Traffic Calming Improvements, Alfriston Stakeholder Engagement

PREPARED FOR:	Andrew Keer (ESCC)
COPY TO:	Karl Taylor (ESCC) & Alfriston Parish Council (APC)
PREPARED BY:	Andy Mileham (ESH)
DATE:	24 th October 2022
PROJECT NUMBER:	678223-SCH:149
TECHNICAL NOTE:	05
APPROVED BY:	Andy Mileham (ESH)

Project	SCH-0149 - ALFRISTON
Drawing title	PROPOSED 20MPH SPEED LIMIT PRELIMINARY WITHOUT BUFF RESURFACING

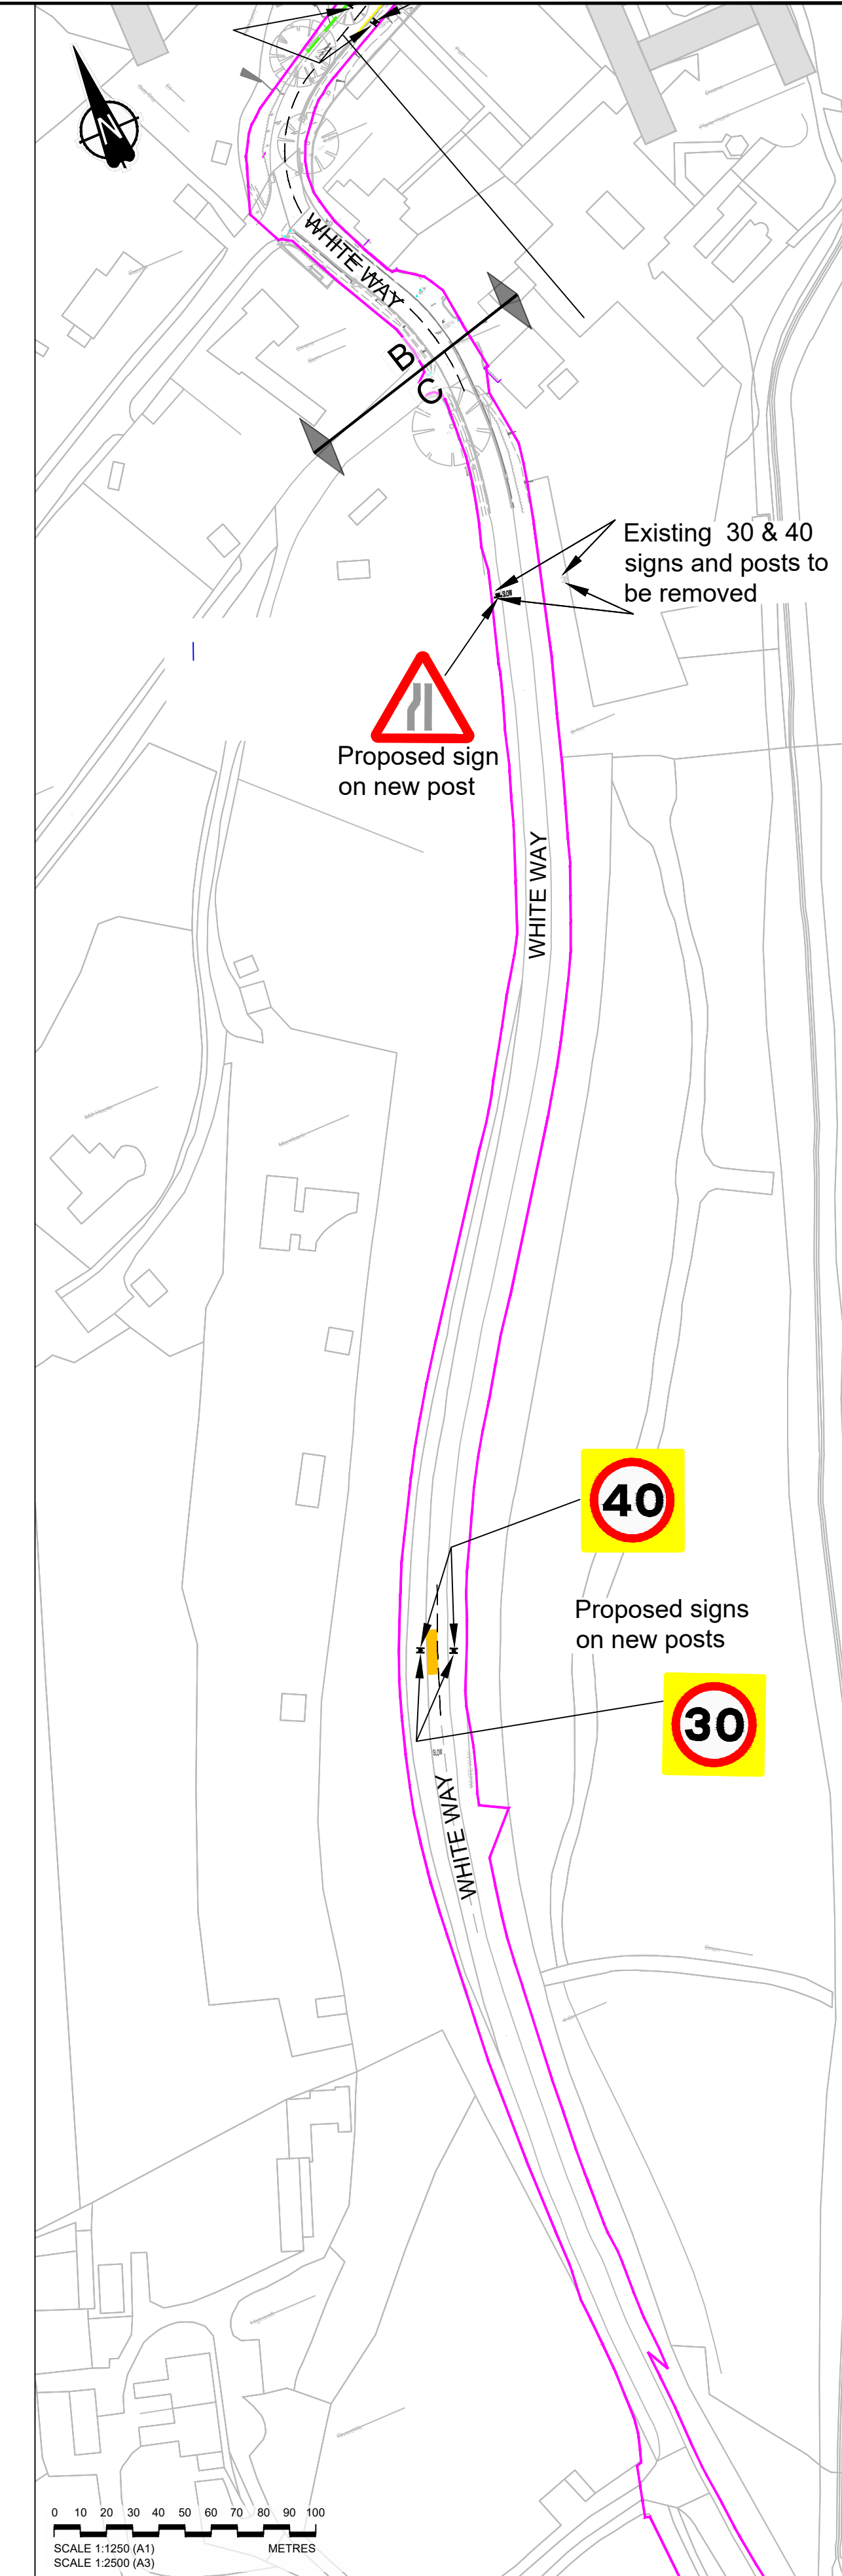
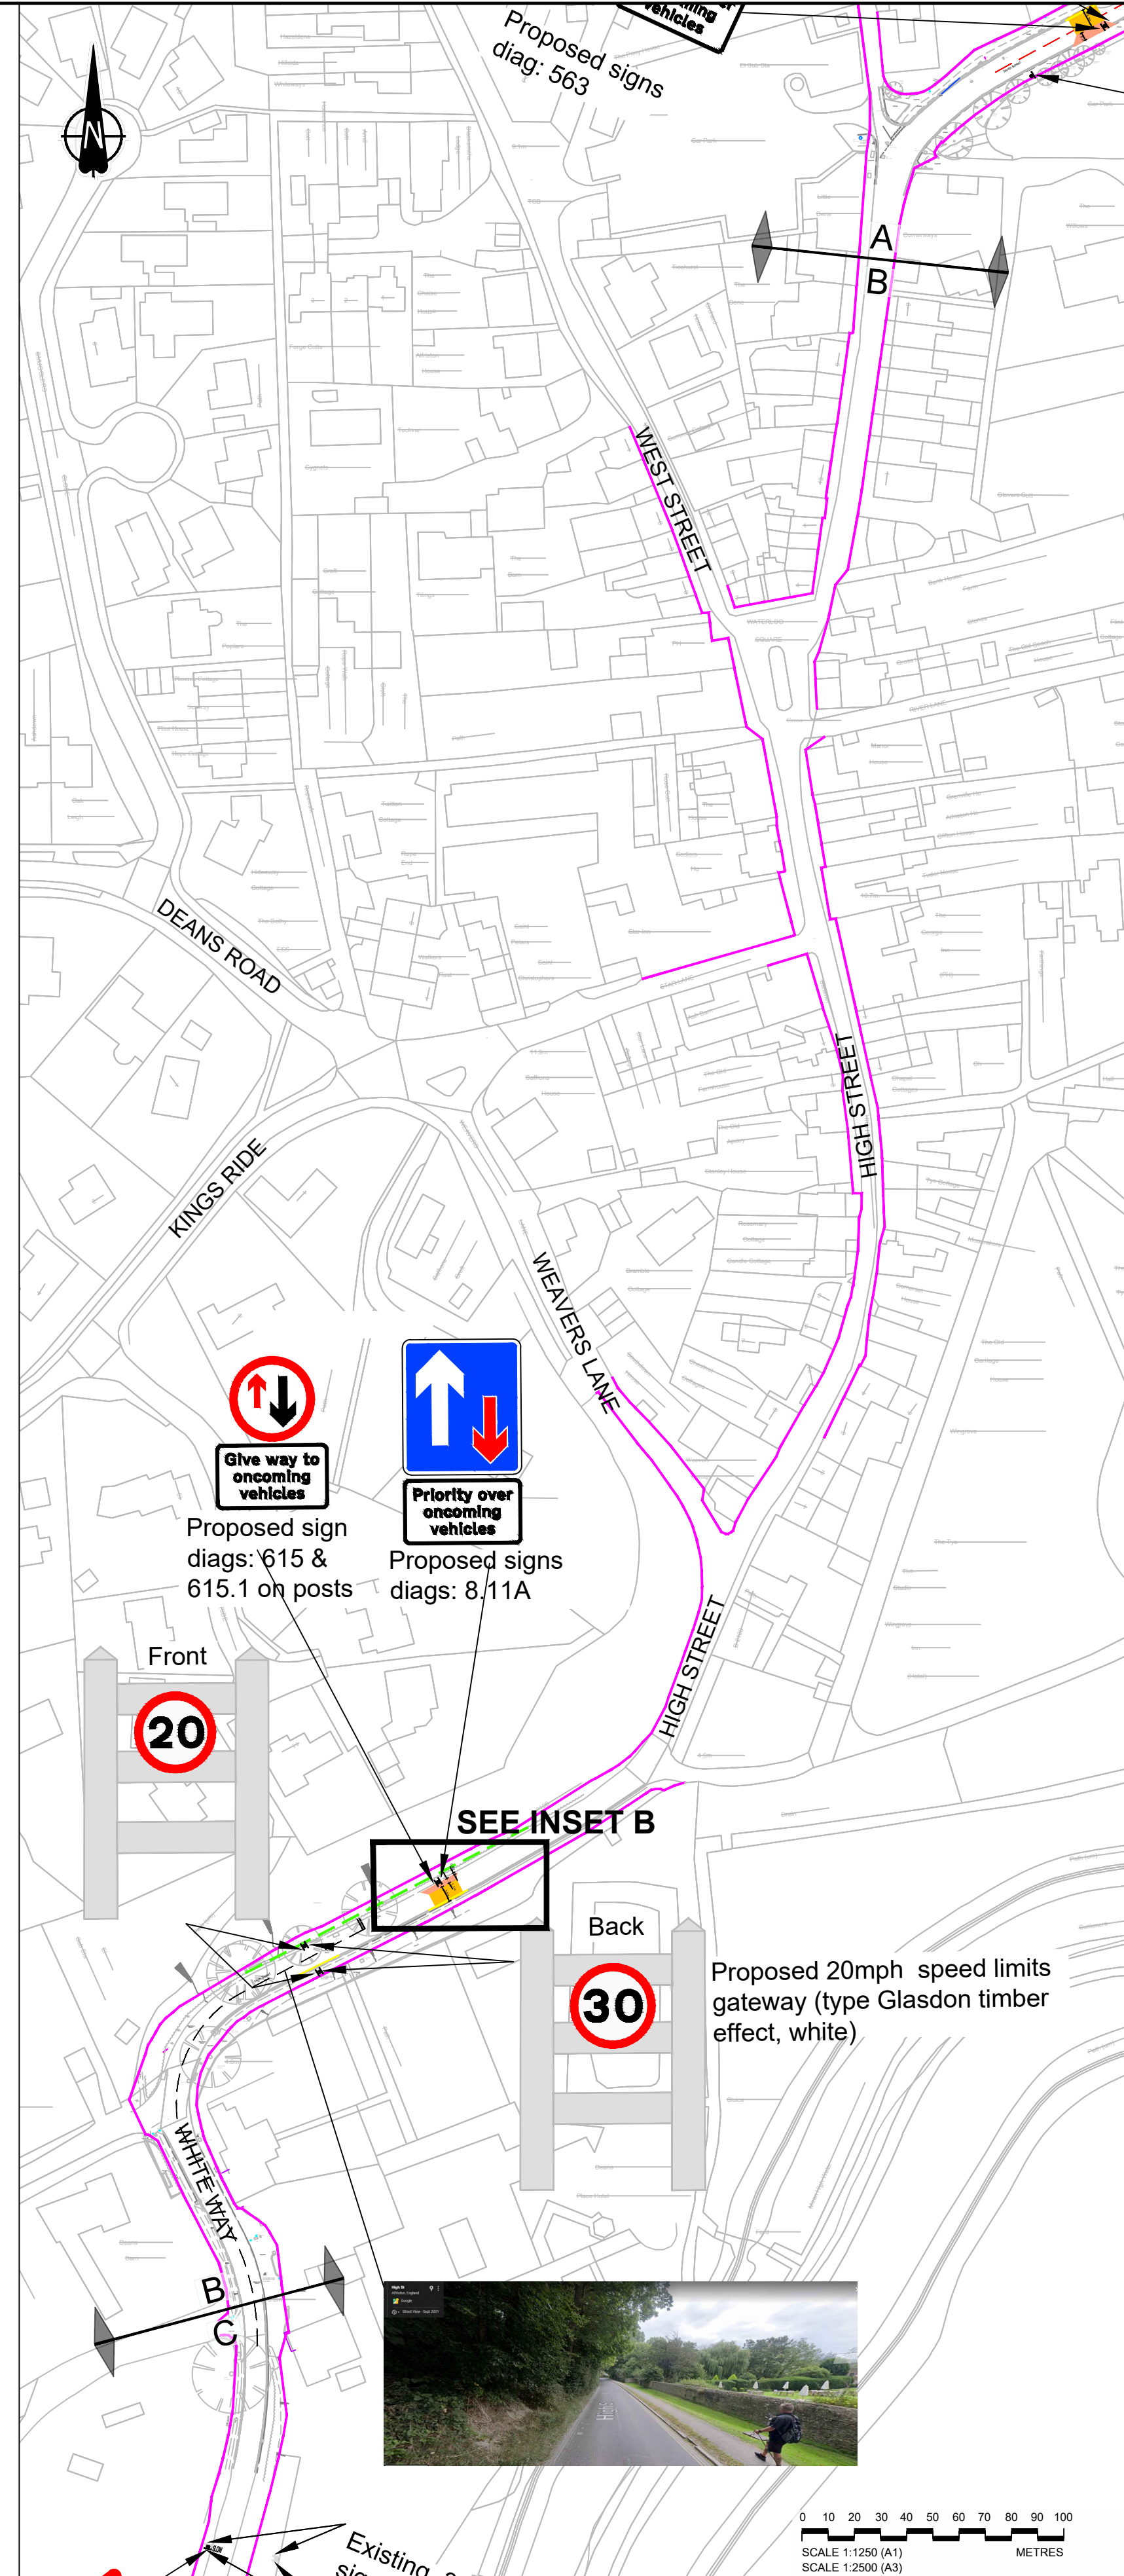
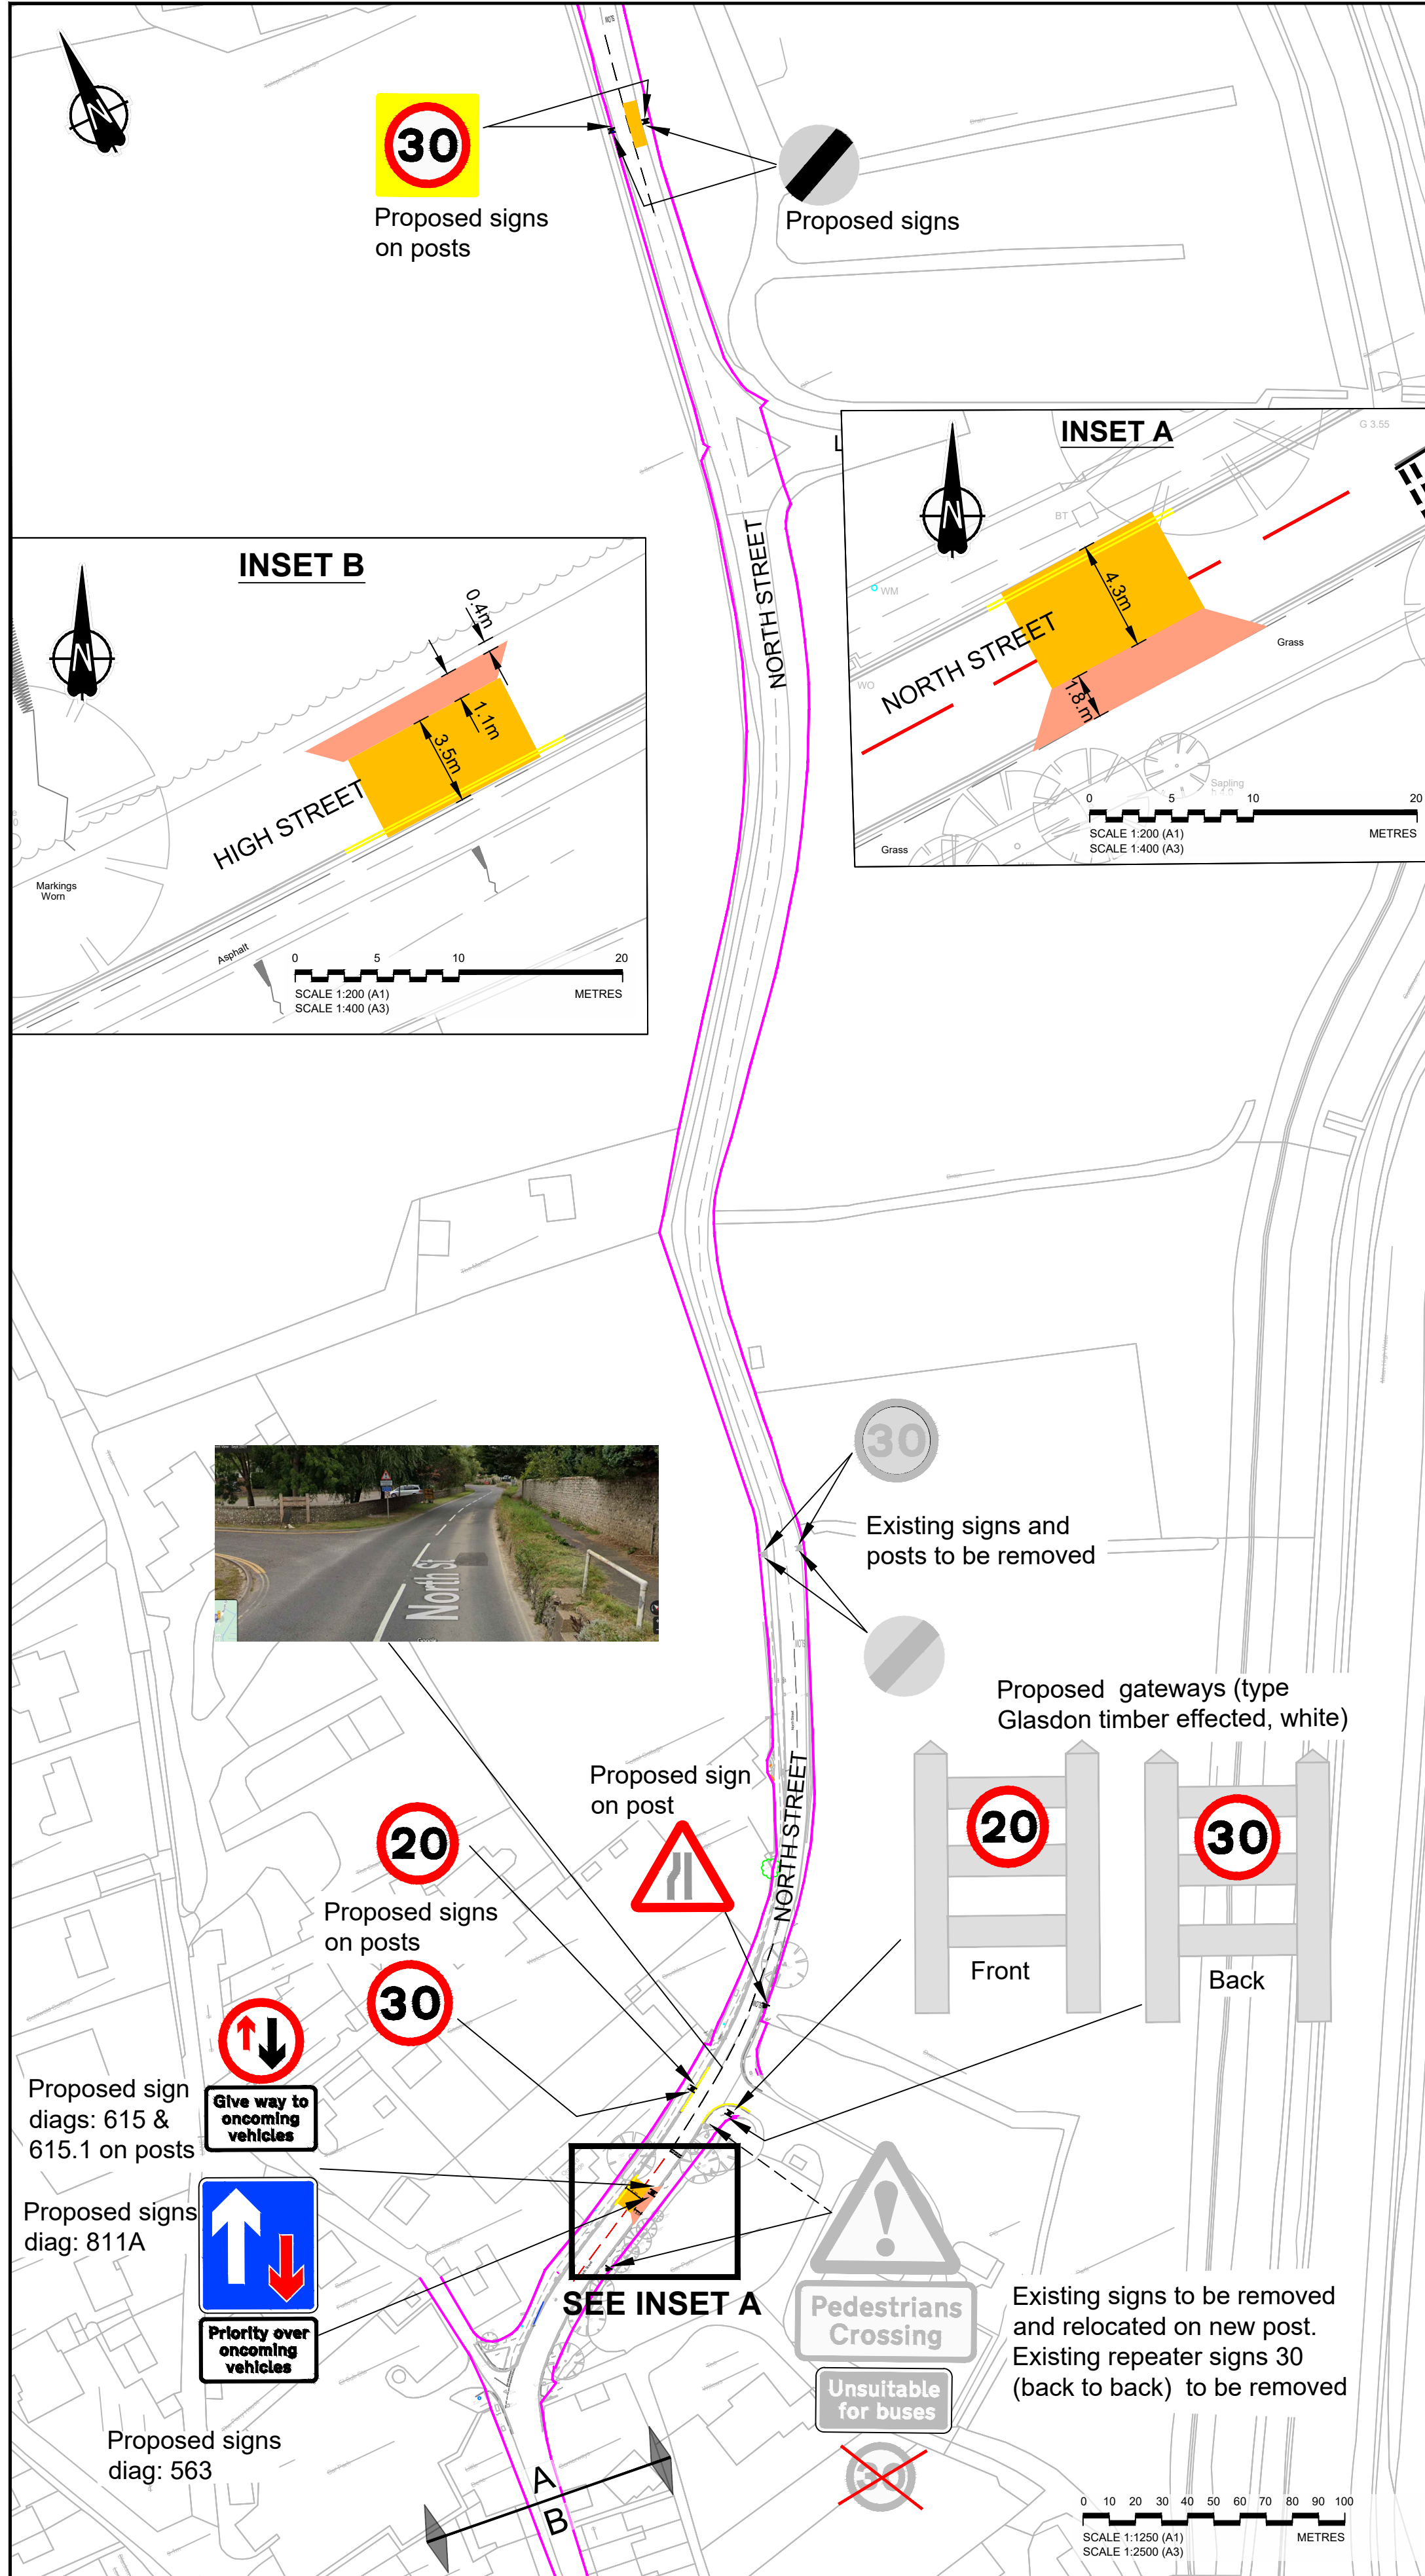
The SDNPA issued the following response on the proposed traffic calming design *“We welcome the reduction of speed to 20mph through Alfriston, though given the intention to slow traffic with buildouts, and the decision to not include repeater signage, would this not be more appropriate as a 20mph ZONE as opposed to simply a limit? Road features present in Alfriston such as narrow widths, bends and a removal of the centrelines would all count as traffic calming features for the purposes of a ZONE. This would allow for a reduction in clutter including the proposed gateway style furniture, which is being used solely to highlight the change of speed, not serve as a gateway to the village”*

“Additionally, in the interests of reducing clutter, could there be a change of speed (or 20mph ZONE) sign on only one side of the road? The Traffic Signs Manual Chapter 3 states ‘There is no specific requirement to provide two terminal signs, one on each side of the carriageway, where the speed limit changes along a length of road.’ therefore could the infrastructure be limited to solely the carriageway where the traffic is to be slowing”.

“If the gateway style furniture is insisted upon, as is being discussed in the developing ‘Communities in the South Downs’ guidance and accompanying National Park appropriate ‘Catalogue of Interventions’, within the park it is preferred that gateway furniture be made of timber or other locally significant materials in the first instance. While I recognise there may be some concerns regarding passive safety, Hampshire County Council are currently trialling passively safe timber gateway furniture and could be contacted for advice”.

“Again, the SDNPA approve of the use of a buildout to reduce traffic speed, with priority for traffic leaving Alfriston, but would request that the verge/embankment in each of these locations be continued into the buildout, rather than the whole thing be topped with tarmac. The kerbing for these buildouts should match the conservation kerbing used throughout Alfriston. Additionally, there is an excess of clutter. There may not need to be the large amount of signage.”

“Traffic Note 9/94 (Horizontal Deflections) makes mention that the Highways (Traffic Calming) Regulations 1993 allows for warning signage at horizontal deflections (like chicanes and buildouts) to be omitted in areas where the speed limit is 20mph. Part of this scheme is to reduce the speed limit to 20mph including the areas where the buildouts are located. Without explicit signage, drivers should fall back on the advice of the highway code, rule 163 of which states drivers should ‘give way to oncoming vehicles before passing parked vehicles or other obstructions on your side of the road”.

“In addition to the signage above, the Traffic Signs Manuals note that ‘Yellow backing boards can be especially environmentally intrusive, and their over use could eventually devalue their attention attracting benefits. A less garish way of increasing a sign’s conspicuity is simply to provide a standard sign of larger size.’ Therefore, we would request that this advice is followed, possibly alongside producing the signs with a higher level of retro-reflectivity, if these signs need to be made more conspicuous, rather than yellow backing boards.”

“The SDNPA recognise that there is to be little benefit to adding ~30m of centre lining on a road which does not already have centre lines. If this was to highlight the change of speed, this is mentioned in the Traffic Sign Manuals as an option to replace existing centre lining, not really stating that new markings should be added where there are not any currently. Edge marking, possibly forming a virtual narrowing, would be a more appropriate method of drawing attention to the new speed limit”.

“The addition of the small areas of buff surfacing is not suitable for a rural village in a national park setting. Especially as this is a compromise from the Parish's request for a change of surface throughout the 20mph area. With the buildouts, lack of centre lining and the nature of Alfriston itself, these additional, unsympathetic, items of clutter may not be necessary for informing drivers they have entered a different road space.”

“The removal of centreline markings from the gateway on North Street is supported by the SDNPA but does raise the question of why additional markings are being added on the approach to the White Way change of speed where there are no markings currently. We do not support adding additional centrelines in locations where there are none currently, especially as there is no advantage in safety at this location as CrashMap shows no injury collisions in this location for the last 5 years. Indeed, a lack of centre lining would add additional emphasis to the give way markings for the buildout.

ESH Response - Paragraph 3.2.16 of LTN 1/07 states A 20 mph zone should have entry treatments with signing at the gateways to the zone and suitable speed reducing measures. Within the zone speed control measures are needed, which are broadly defined in TSRGD 2002 (e.g., road humps, raised junctions, speed cushions, horizontal deflections, mini roundabouts, bends and reductions in the width of the carriageway.) The fact that the roads are narrow with bends would therefore not be considered as introducing speed control measures.

ESH Response – While the SDNPA is correct that the Traffic Signs Manual Chapter 3 does state that *“there is no specific requirement to provide two terminal signs, one on each side of the carriageway, where the speed limit changes along a length of road”*. However, Chapter 3 then highlights *“in most situations it is recommended that two signs are provided, particularly on motorways and rural dual carriageway roads. Drivers need to be fully aware of the speed limit both for reasons of road safety and enforcement, particularly where the sign indicates a reduction in the speed limit”*.

Given the rural location, there is always the possibility that a single sign might become damaged or obscured by vegetation and require a more rigorous maintenance regime. A single sign could also be obscured by high sided vehicles, particularly on roads with more than one traffic lane in the same direction. Hence, the reason to include two terminal signs was justified.

ESH Response – While ESH would not have an issue in principle with using timber for the construction of the gateway features, a full risk assessment would be required to assess the potential impact that the material would have specifically in relation to passive safety. Long term maintenance would also need to be agreed with ESH or the APC (depending on who will be responsible for maintaining any of the features).

ESH Response – Again, ESH don’t have any problems in principle if the buildouts were ‘filled’ with soil/grass instead of blacktop. Consideration would need to be given to the long-term maintenance of the area and how this would be undertaken in a constrained area, and both ESH and ESCC would need to be satisfied that any vegetation that may take hold will not impact visibility of any reflective material that may be present on posts/bollards etc.

ESH Response – Whilst guidance states that they could indeed be removed within 20mph speed limits, ESH would need to be convinced that the speed limit is not going to be exceeded and that forward visibility of each feature is such that an approaching driver can see far enough ahead to make a decision about whether it is safe to proceed. Therefore, it is recommended that a monitoring period of 3 months be implemented once the scheme has been implemented.

ESH Response – ESH agree with the SDNPA comment and that ‘yellow backing boards’ are not required if visibility of the proposed sign meets the recommended design specifications.

ESH Response – ESH agree with the above comment about edge marking, thus forming a ‘virtual narrowing’ which will be investigated further.

ESH Response – While there is no specific requirement for a coloured road surface other than to draw a driver's attention to the change of environment, it is considered that the more visual impact that is experienced by a driver in these specific locations, the greater their speed will be reduced as they enter the village, hence the reason for its current inclusion.

ESH Response – As stated previously within this TN, the proposed design options have undergone a GG119 Road Safety Audit (Stage 1) and has been approved by the ESCC RSA team. The point regarding the additional centreline road markings on the approach to the White Way has been incorporated in order to reduce vehicle speeds/driver awareness before they reach the 20mph gateway area. However, further investigation into if the centreline can be removed will be undertaken after the public consultation stage of the project.
